REPORT OF COMPLIANCE SAMPLING INSPECTION
OF THE
ROCKAWAY BEACH WASTEWATER TREATMENT FACILITY
IN
ROCKAWAY BEACH, MISSOURI

NPDES PERMIT NUMBER: MO-0108162

SEPTEMBER 10-13, 2007

U.S. ENVIRONMENTAL PROTECTION AGENCY
Region VII
Environmental Services Division

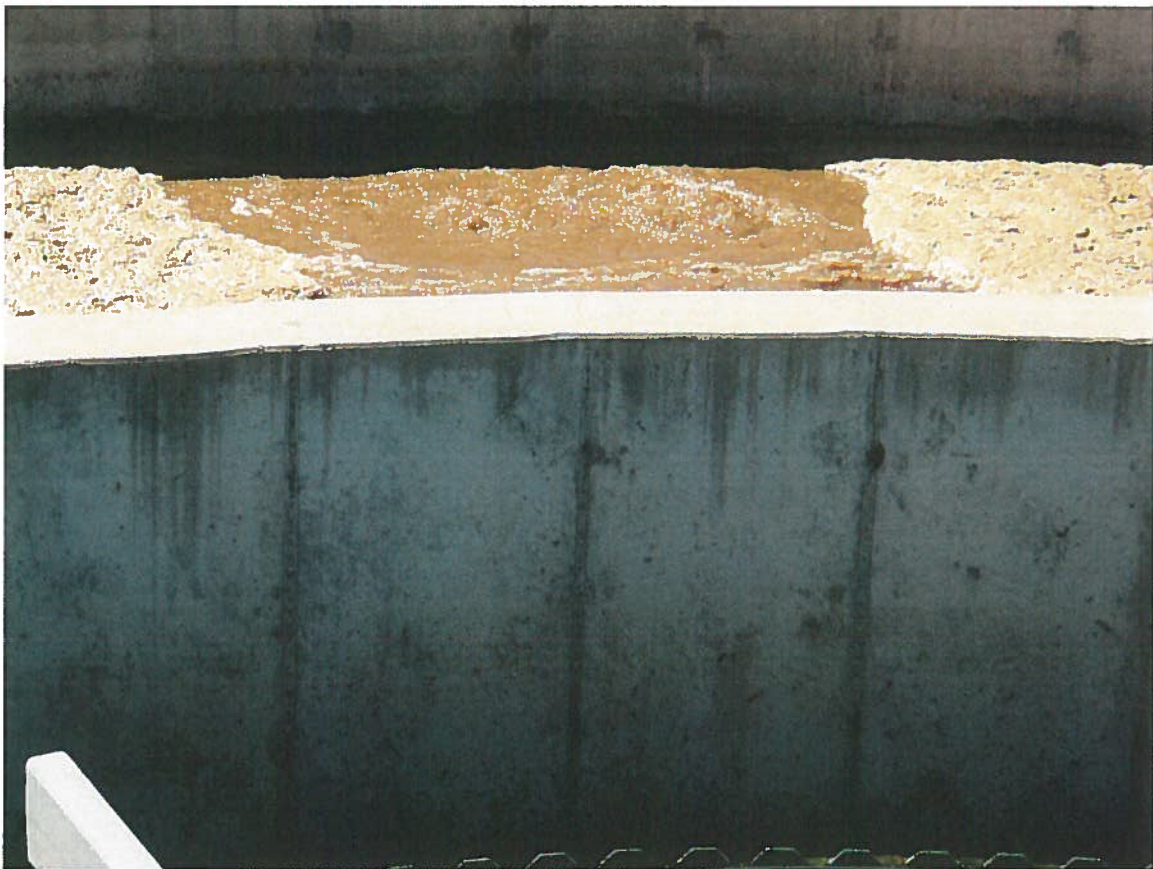
Photo no. 3 This photo was taken looking northwest from the headworks structure looking at the west aeration basin. Note the large boil type aeration pattern. A fine bubble pattern would add more air. The building at the upper center is the laboratory/office. Located at the right edge of the photo is the raw sewage pump building.

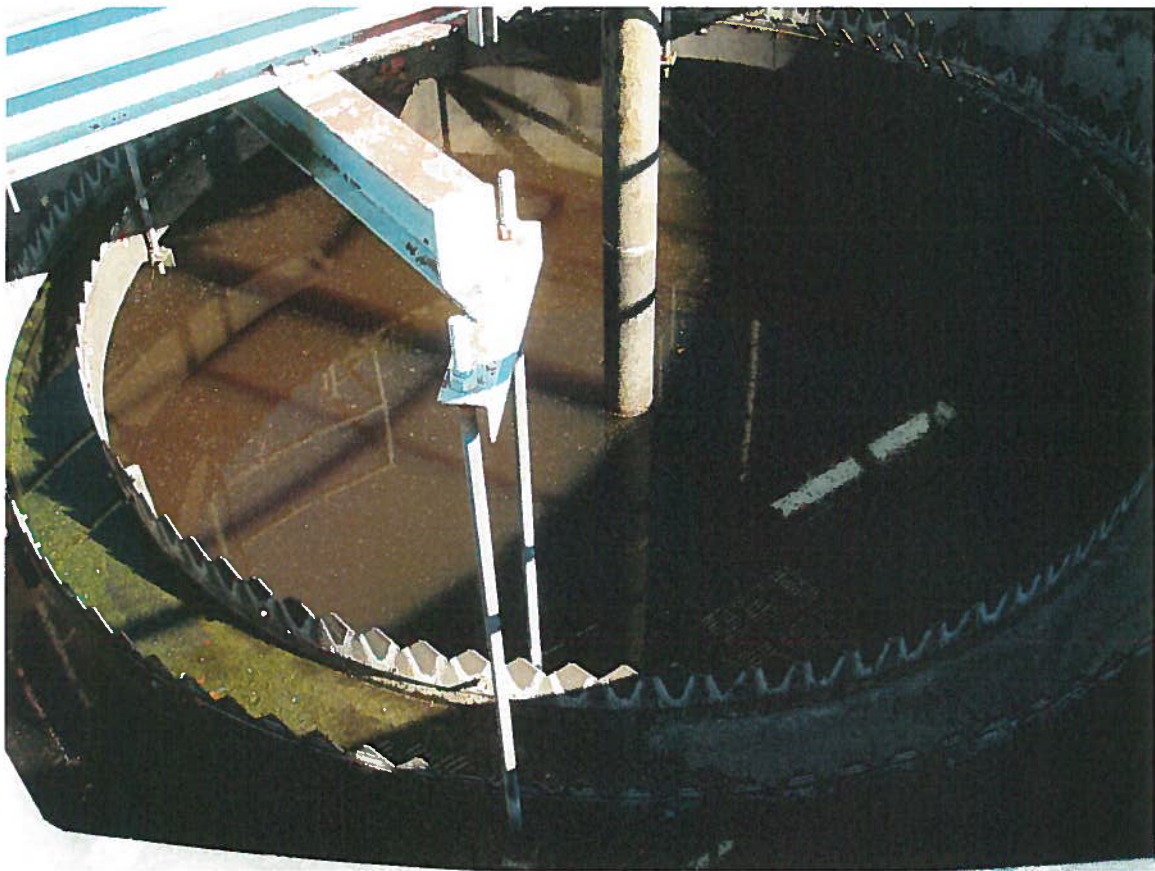
Photo no. 11 This photo was taken from the old sludge storage tank looking north. It shows the two old final clarifiers that were intended to be used as sludge thickening tanks. They are used as such with the water decanted manually using a pump. The sludge is pumped from these tanks into the liquid sludge haul truck which can be seen at the upper right.
